AQUALLIANCE

April 29, 2022

Re: Butte Subbasin Groundwater Sustainability Plan

Butte GSP Primary Aquifer Monitoring Wells
 CASGEM Wells Nos. 19782 and 23978
 Historical Groundwater Elevation Difference

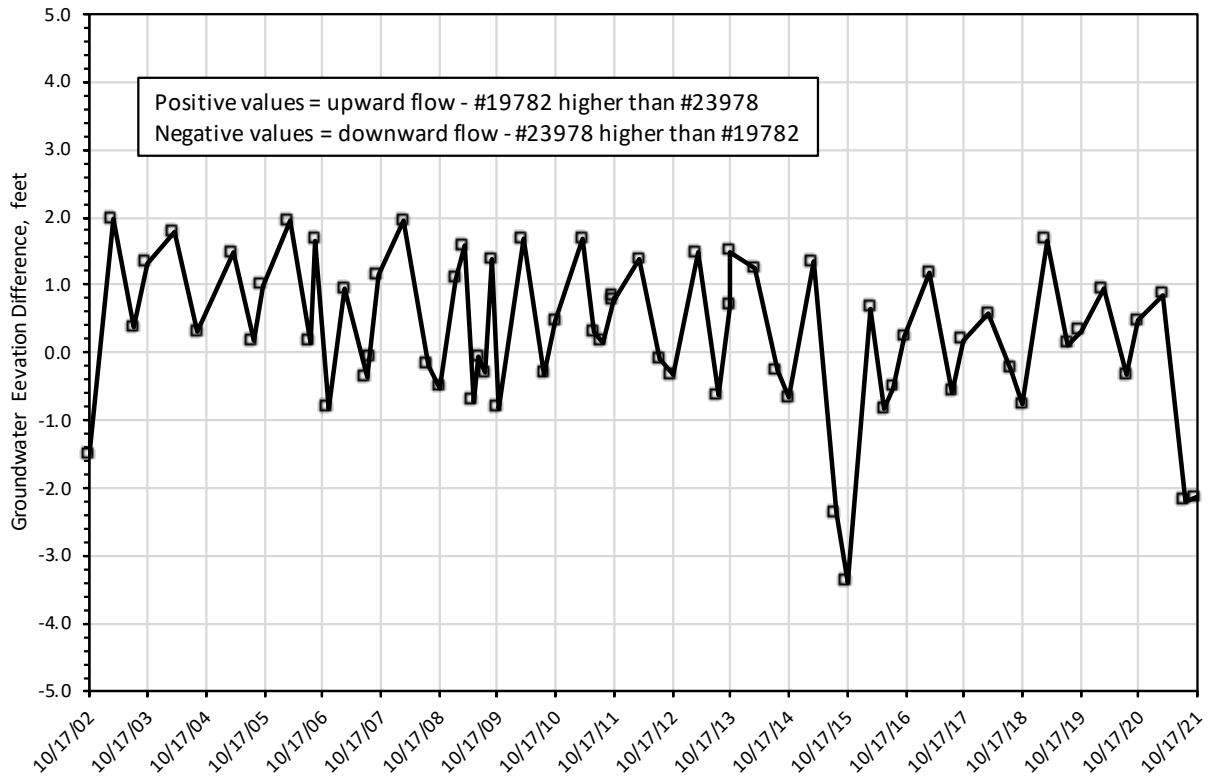
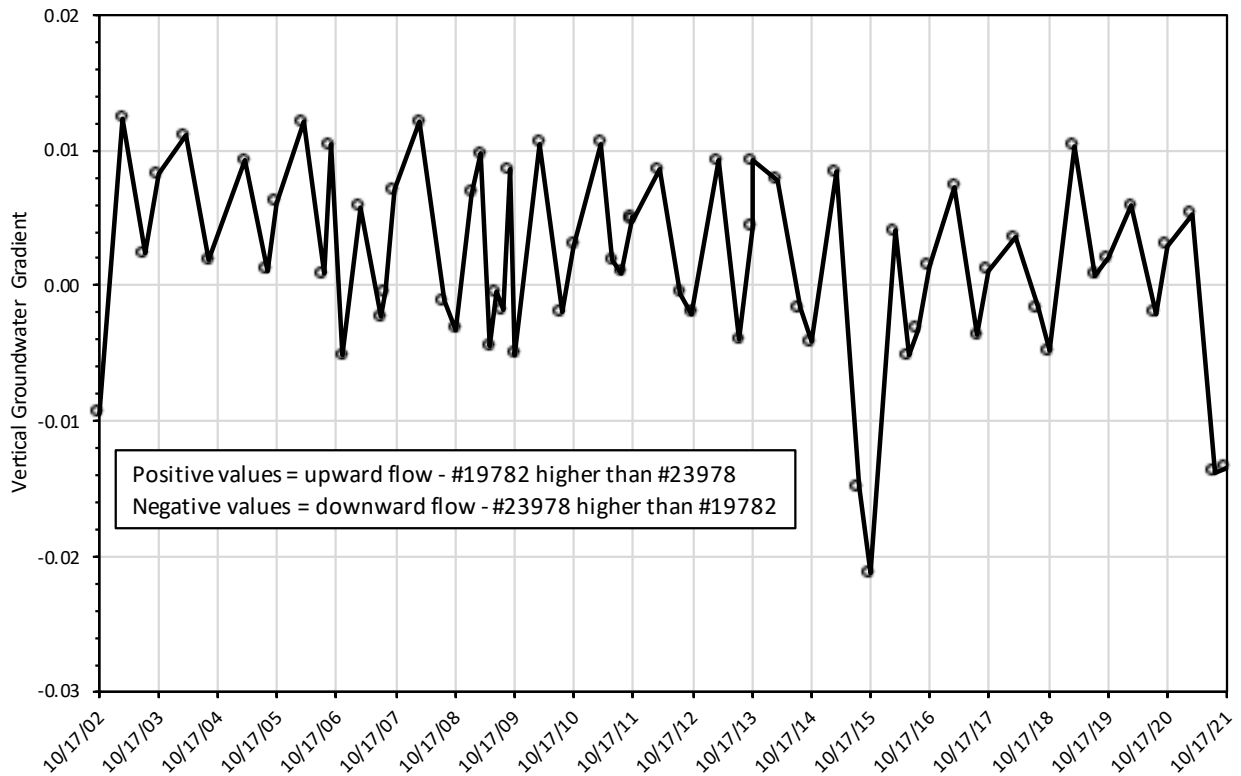
These two wells are less than 1 mile apart, and the middle depth of the screened intervals is approximately 160 vertical feet apart. Historical groundwater level data from CASGEM shows that the depth to groundwater in both wells is typically less than 5 to 10 feet, with the average in recent years less than 5 feet. Historical CASGEM data show that the difference in groundwater elevations between these wells has ranged from -1 to -2 feet, except for the years 2015 and 2021, when the difference ranged from -2 to -3.4 feet (AquAlliance Exhibit 8A). Using the vertical screen difference of 160 feet, the historical vertical groundwater gradient between these two wells ranges from approximately -0.013 to 0.021 (AquAlliance Exhibit 8B). Assuming that these two wells in the center of the subbasin and less than a mile apart are in the same 25% RMS groundwater level monitoring group, the requirement that the MTs in these wells be exceeded together for 24 consecutive months before an undesirable result can occur raises several questions:

- Why are the MT depths for these two wells 19 vertical feet apart when they historically have been less than 2 feet apart?
- Why set the MT depths 19 vertical feet apart when that produces a downward vertical gradient of approximately 12%, or approximately 9 times greater than the historical values ($19 \text{ ft} / 160 \text{ ft} = 0.119 = 11.9\%$ vs historical 0.013 or 1.3%).

- What subbasin management activities are anticipated that would produce this high vertical gradient for a period of at least 24 consecutive months?
- Assuming that these two wells that are less than 1 mile apart are in the same 25% RMS well group, wouldn't the depth to groundwater in shallower well, B-26, need to be far below its MT to trigger an undesirable result because of the MT depth in well B-25?

Modified Figure 4-5: Interconnected Surface Water Representative Monitoring Network with MTs (DTW)

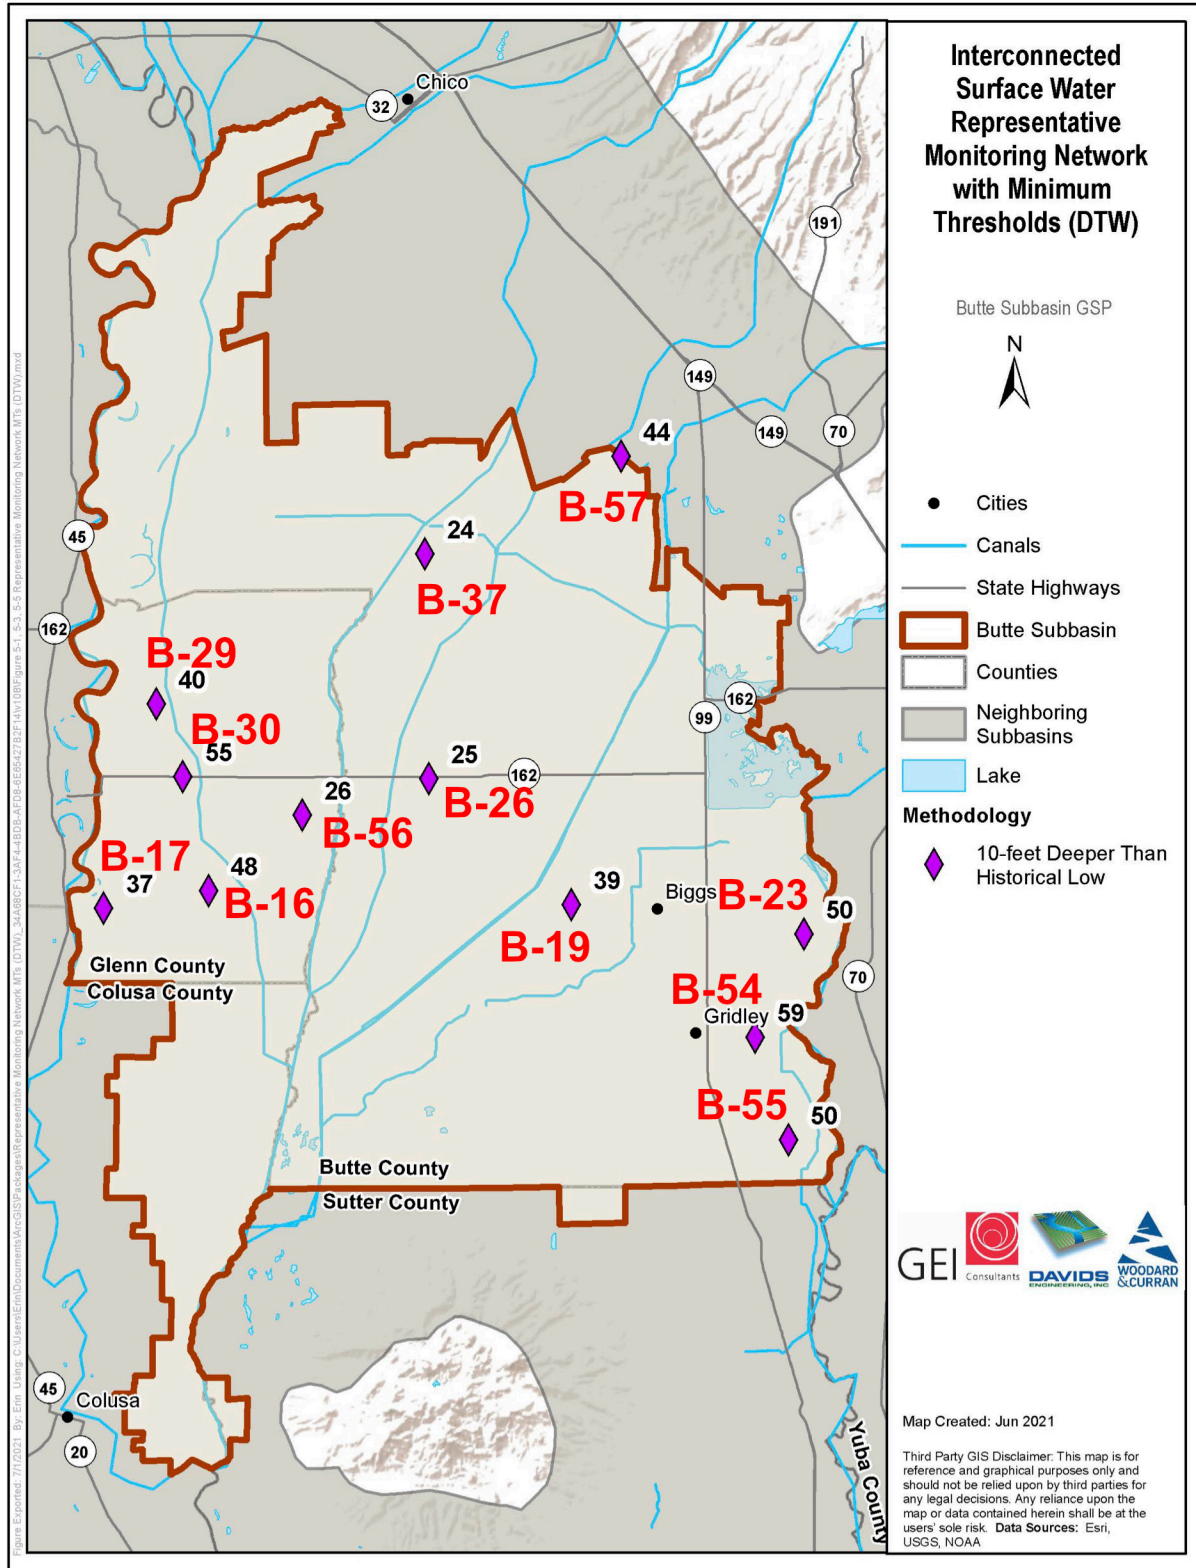
13. AquAlliance Exhibit 9 is a modification of Figure 4-5 showing the locations and values of the MT depths to water for the Butte GSP ICSW RMS network with the Well ID numbers from AquAlliance Exhibit 1 added. The Butte GSP ICSW sustainability criterion requires that the MTs be simultaneously exceeded in 3 of the 12 RMS wells, or 25% of the wells, for 24 consecutive months (Table 4-3, p. 4-34, pdf 232 and Section 4.2.6.4, p. 4-12, pdf 210). The Butte GSP doesn't name the ICSW monitoring wells in a 25% group, the area covered by a group, whether the wells in a group need to be adjacent or can be dispersed across the subbasin, whether the wells can be grouped so that all the wells in the areas of deepest decline are considered together, whether more than one 25% group is allowed, whether more than 3 wells can be in a group, or whether the wells in a group can change. The Butte GSP does state that there is a project to add 10 wells to improve monitoring of surface water depletion and GDEs with all 10 of the new shallow wells monitoring GDEs and 7 of the wells added to the ICSW network (Section 5.9.2, p. 5-51, pdf 283 and Figure 5-2, (p. 5-52, pdf 285).

For example, two of the wells shown in AquAlliance Exhibit 9 near the center of the subbasin adjacent to Highway 162, labeled B-26 and B-56, are an example of one issue with the ICSW monitoring network. What is the criterion for including a ICSW well in a 25% group? One of these two wells, B-26, was previously discussed in Comment No. 9 because it has two MT depths that are 10 feet apart, at 25 and 35 feet bgs (AquAlliance Exhibit 1). The second ICSW well, B-56, has an MT depth of 26 feet bgs. These two ICSW wells are adjacent to two different streams, Butte Creek and Little Dry Creek (see Figure 2-10, p. 2-5, pdf 88). The logical choice for a third well in the 25% group would be the well along the same streams, such as B-37 to the north that's between these two creeks. Well B-37 has an MT of 24 feet bgs, which is consistent with the other two

- What group of three wells does well B-57 to the northwest belong to? Can it be included with the other three wells to make a group of 4 wells?
- Well B-57 is adjacent to Little Dry Creek, but the MT depth is 44 feet, which creates the *waiting for exceedance of the maximum depth* problem if it's combined in a group with the other three wells, because there's a 20-foot MT depth difference.

- Can these two northern ICSW monitoring wells be effective at identifying when and where streamflow is being lost when they are 6 to 12 miles away from wells B-26 and B-56?

- Well B-57 is too far away from the other 9 ICSW monitoring wells and not associated with any of their streams, so why would it be grouped with those wells? Note that the proposed additional 10 monitoring wells don't solve this issue (see Figure 3-6, p. 3-22, pdf 198).

- The three wells in the southeast — B-23, B-54, and B-55 — are a logical group. But to what group should well B-19 belong? Again, can there be 4 or more wells in a group? If there are 4+ wells in a group, do all wells have to exceed their MTs or just 3 wells? See Comment No. 2 for discussion of other issues related to additional wells in a group and the timing of the 24-month clock.

The Butte GSP ICSW RMS network needs to be revised and expanded to allow for effective and protective monitoring of the subbasin surface water features, so that measurements protect the beneficial uses and users, especially in those the sections of streams where future losses are anticipated. The location of ICSW monitoring wells should be linked to portions of the streams where the habitat is most sensitive and maintaining flows is critical for the survival of fisheries and the habitats of other wildlife and GDEs. The ICSW monitoring wells should also be linked to actual surface water flow measurements to validate that the MT depths are protective of instream flows.
